Subject: INFORMATION: Acceptance of Oregon 3-Tube Bridge Rail

Date: April 22, 2003

In Reply Refer To: HSA-10/B-118

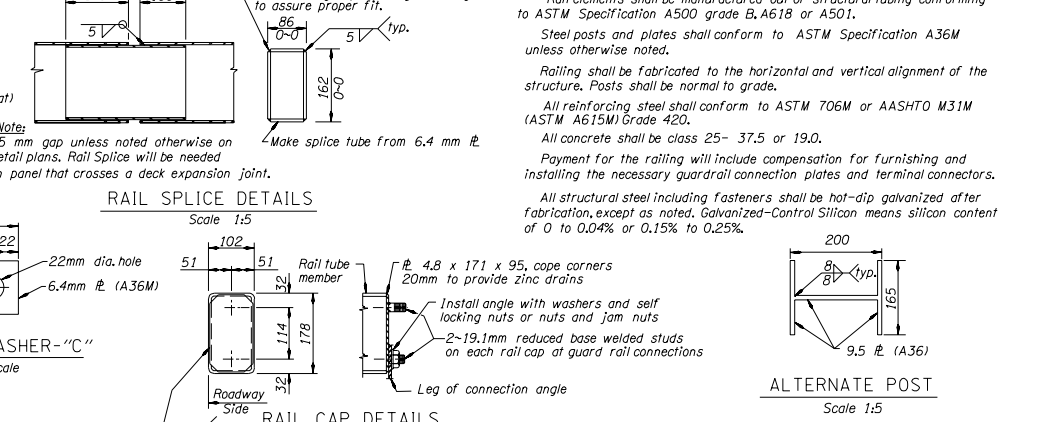
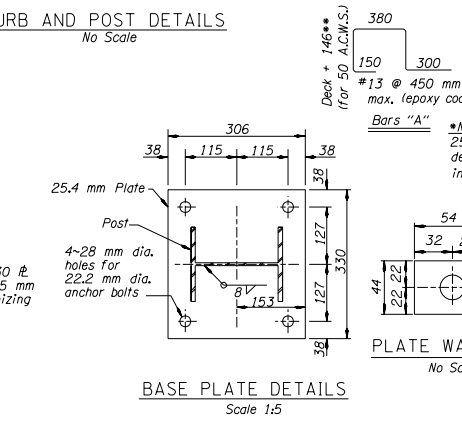
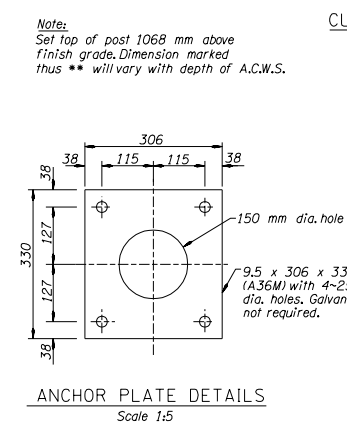
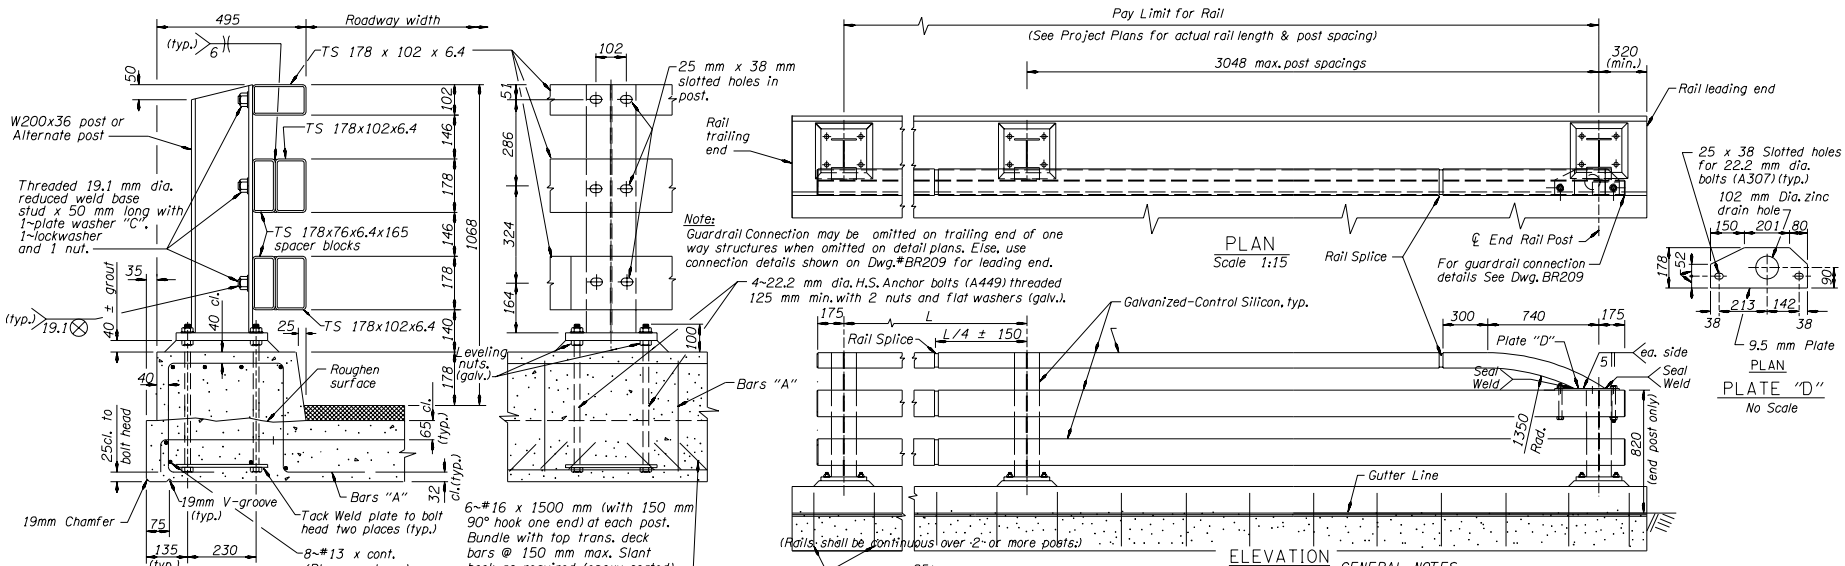
The Oregon 3-Tube Bridge Rail consists of three TS 178 x 102 x 6.4 tubes supported by W200 x 36 steel posts on 3-meter centers. The top rail is 1068 mm above the deck surface, the middle rail is 820 mm above the deck and the lower rail is 496-mm high. The lower two rails are blocked out from the support posts with TS 178 x 76 x 6.4 steel tubes, each 165-mm long. The top tube is installed with the narrow side against the post so the traffic sides of the rail elements lie in the same plane. The posts are mounted on a 178-mm high curb with four 22.2-mm diameter A325 steel bolts. These and additional details are shown in the attachment to this memorandum.

Based on staff review of the three tests that were conducted and their recommendations, I agree that the Oregon 3-Tube Bridge Rail meets all the evaluation criteria for an NCHRP Report 350 bridge rail at TL-4 and that it can be used on the NHS when such use is selected by the contracting authority. Although its crash performance was exceptionally good, I did note that in test 4-11, there was localized bridge deck damage when the two post bolts on the impact side of the rail sheared off. The use of larger or higher strength bolts would most likely minimize repair costs.
